FORD 5R110W Torqshift

FORWARD CLUTCH CHANGES FOR 2005

Technical Service Information

Figure 1

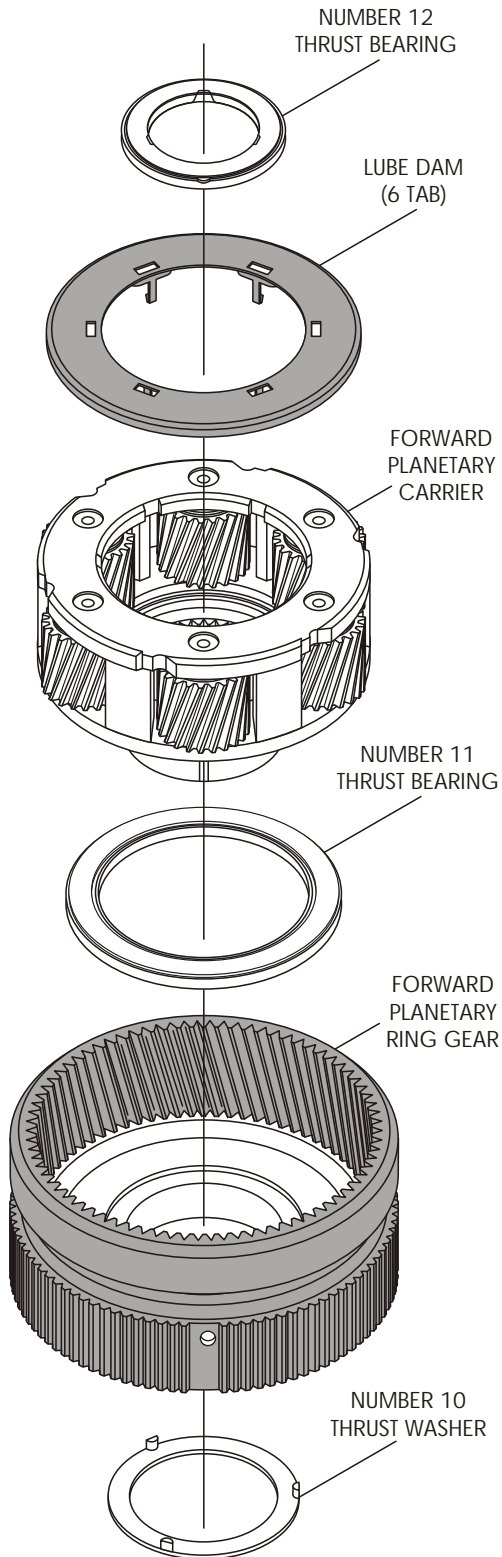
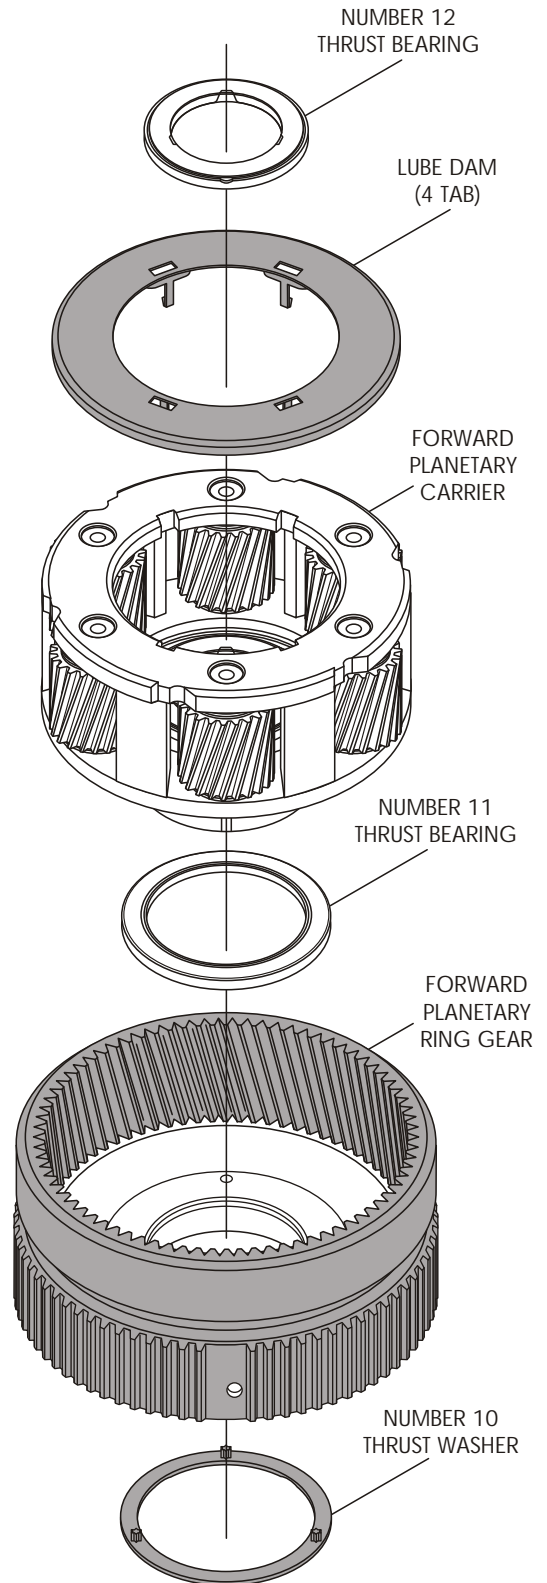
- (1) FORWARD PLANETARY CARRIER - Increased diameter, of approximately 1/4", to the planetary carrier, as shown in Figure 1. Notice also that the pinion pin diameter has increased and the pinion gears are taller than previous models, as shown in Figure 1.

- (2) FORWARD PLANETARY CARRIER LUBE DAM - Also increased in diameter to accommodate the new design carrier, as shown in Figure 1. Notice also that the new lube dam has only four retaining tabs instead of six.

- (3) NUMBER 11 THRUST BEARING - The outside diameter decreased to accommodate the new design planetary carrier, as shown in Figure 1.
- (4) FORWARD PLANETARY RING GEAR - Increased diameter, of approximately 1/4", to the ring gear, as shown in Figure 1, to accommodate the new design planetary carrier. The tooth count on the ring gear for the forward clutch frictions also changed.

- (5) NUMBER 10 THRUST WASHER - Increased in diameter and the tab configuration changed, as shown in Figure 1.
- (6) FORWARD CLUTCH STEEL PLATES - The inside diameter and the pilot diameter increased to accommodate the increased diameter of the planetary carrier, as shown in Figure 2. The outside tooth count did not change.

Figure 3

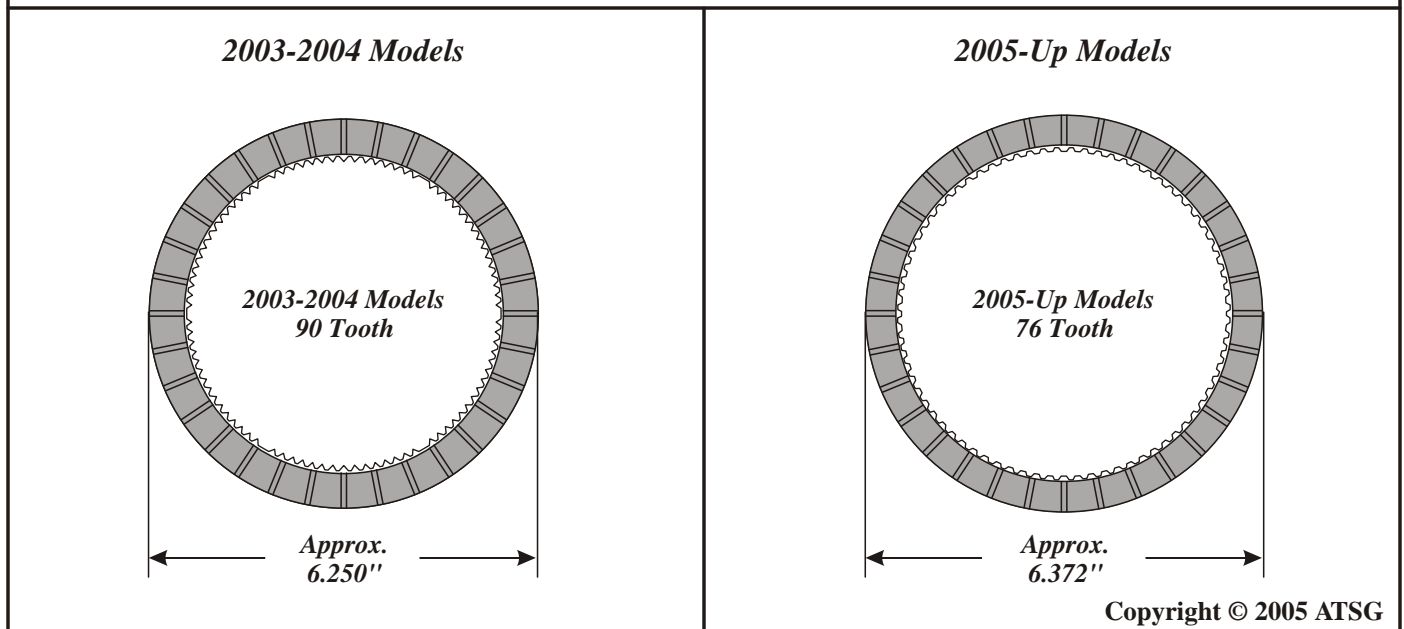
- (7) FORWARD CLUTCH FRICTION PLATES - The inside and outside diameters increased to accommodate the new design planetary carrier, and as a result the tooth count also changed, as shown in Figure 3.

Figure 4

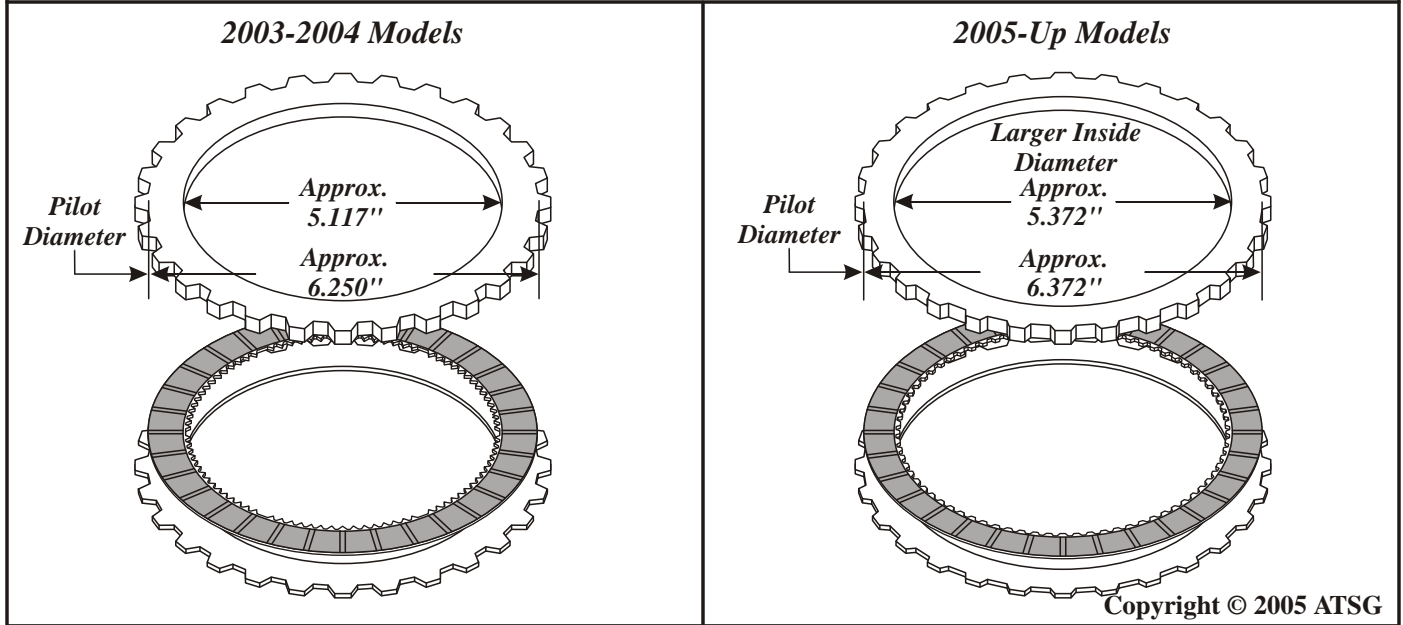
- (8) FORWARD CLUTCH BACKING PLATE - The inside diameter and pilot diameter increased to accommodate the increased diameter of the planetary carrier, as shown in Figure 4. The outside tooth configuration did not change.

Figure 5

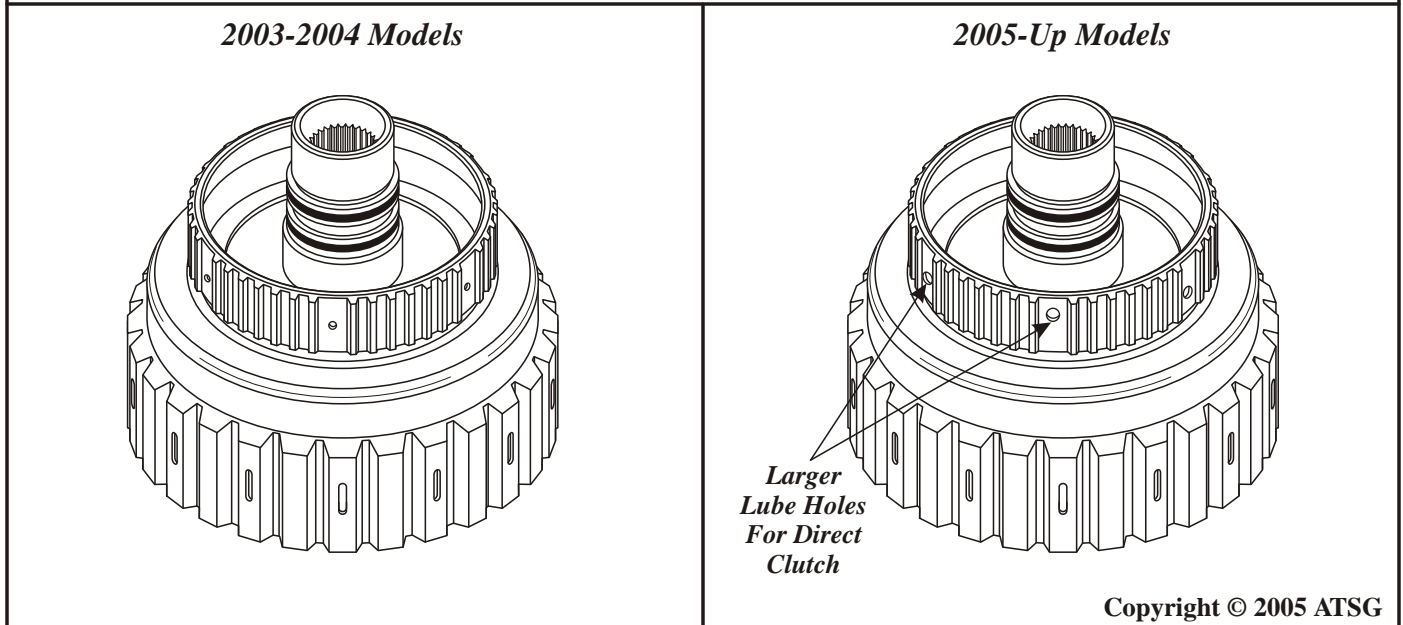
- (9) FORWARD CLUTCH HOUSING - The only thing that changed on the forward clutch housing was the diameter of the lube holes in the hub for the direct clutch plates, as shown in Figure 5.

Figure 6

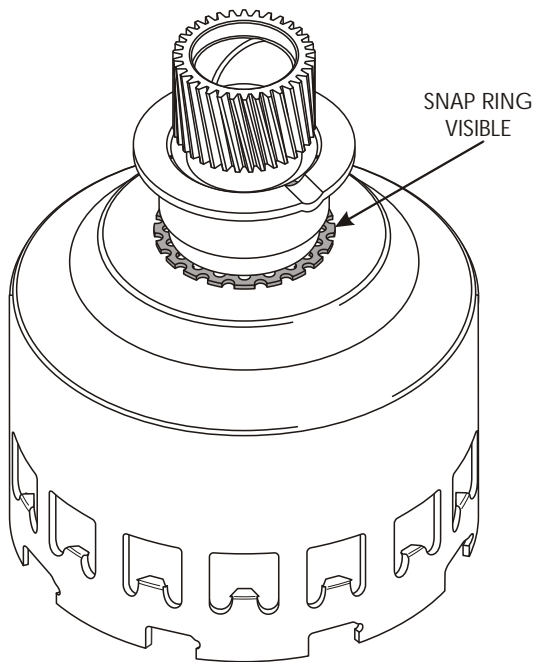
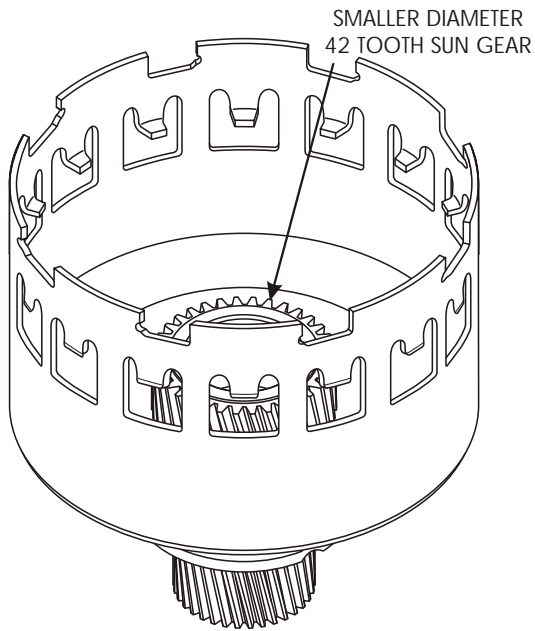
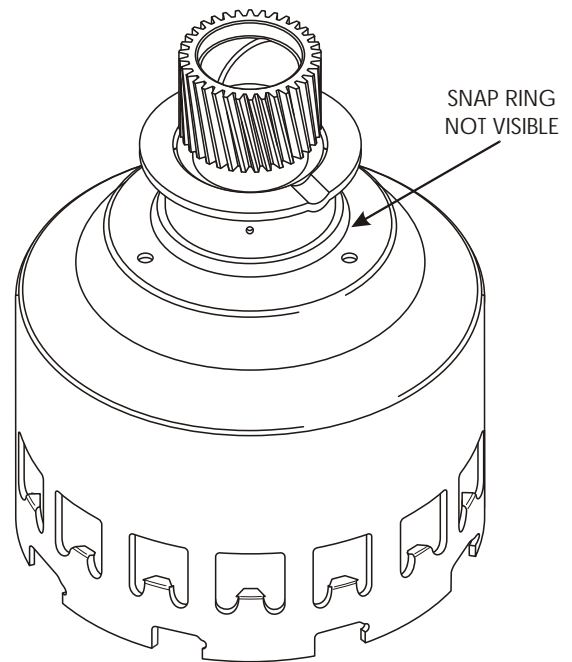
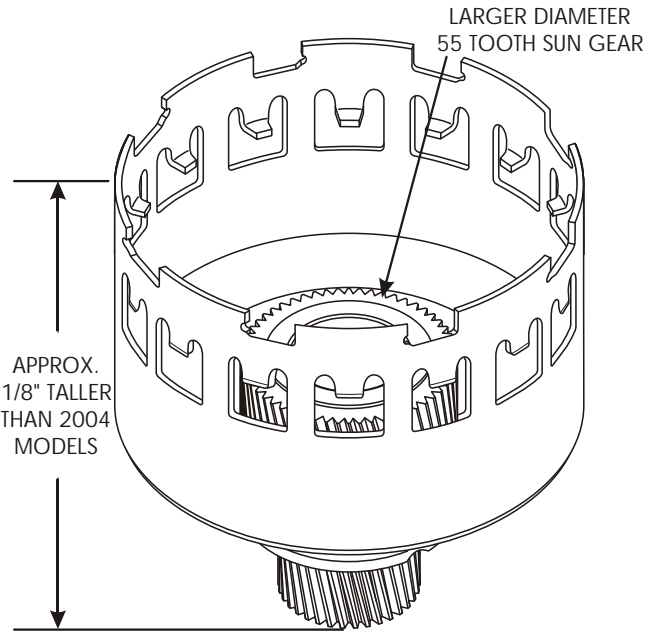
- (10) SUN GEAR AND SHELL ASSEMBLY - The diameter and tooth count of the sun gear for the forward planetary side has increased, as shown in Figure 6. Also from the back side the snap retaining snap ring is no longer visible on the 2005 design, as shown in Figure 6.
